# OICA contribution to PMP

## 22 Nov 2023

- Statement on Brake Particle filter testing
- Correlation of Method B and Method D (CAN)
- OICA input to ILS-3
- Aftermarket and Original replacement parts – definitions

## Equivalency Criterion

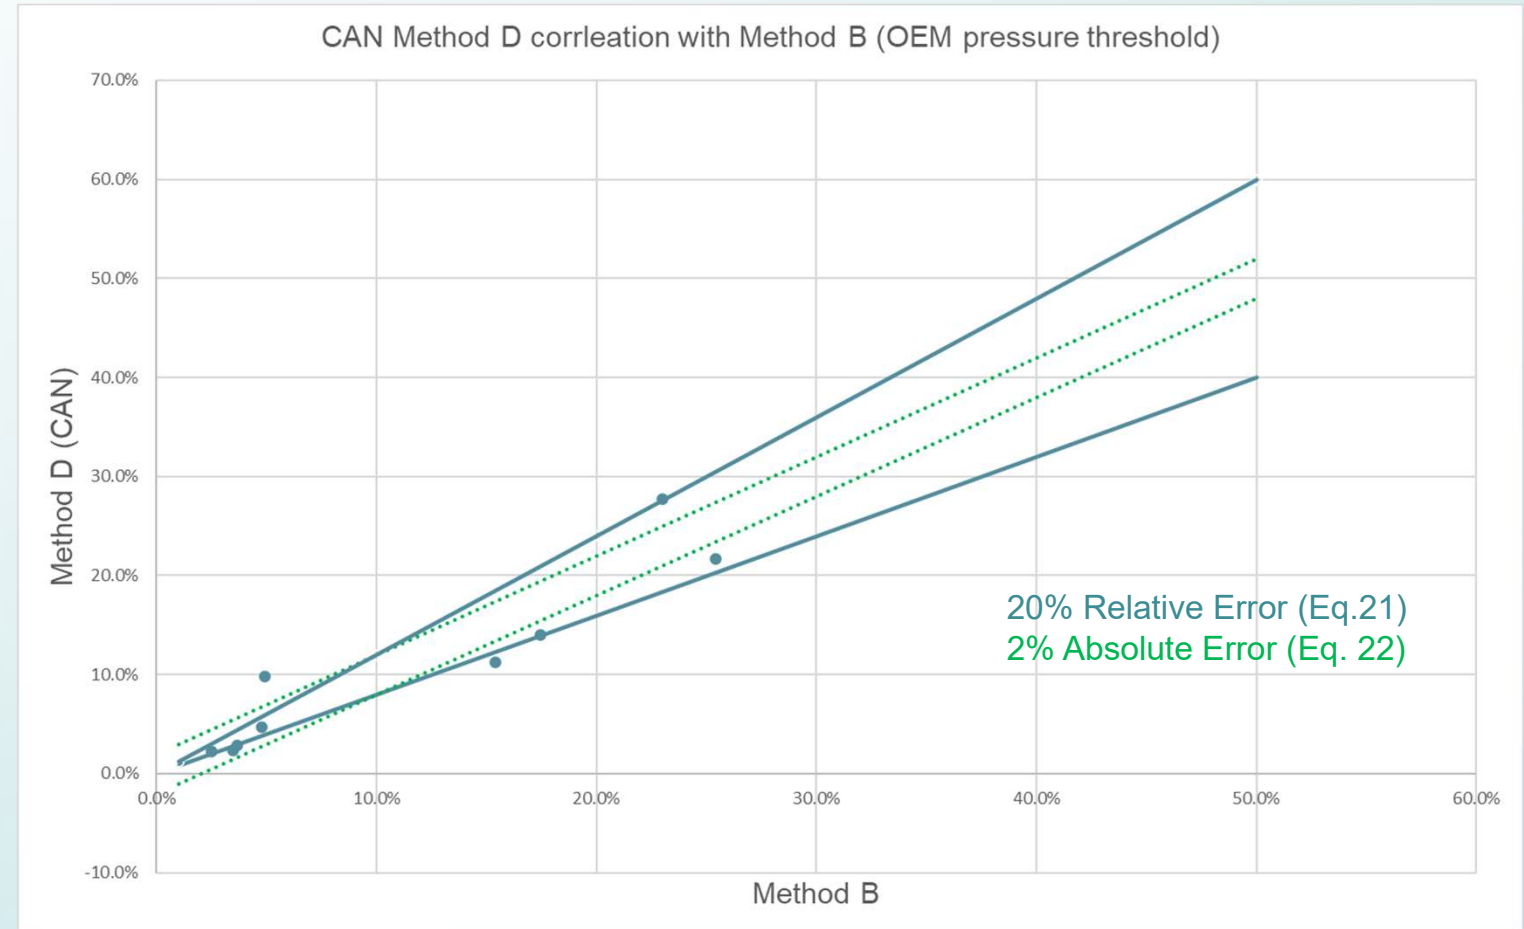
## Propose slight clarification:

“The alternative method shall be deemed to be equivalent to the reference method if ~~one~~ **any** of the following conditions is fulfilled”

- OICA proposal: 20% relative error, or 2% absolute error
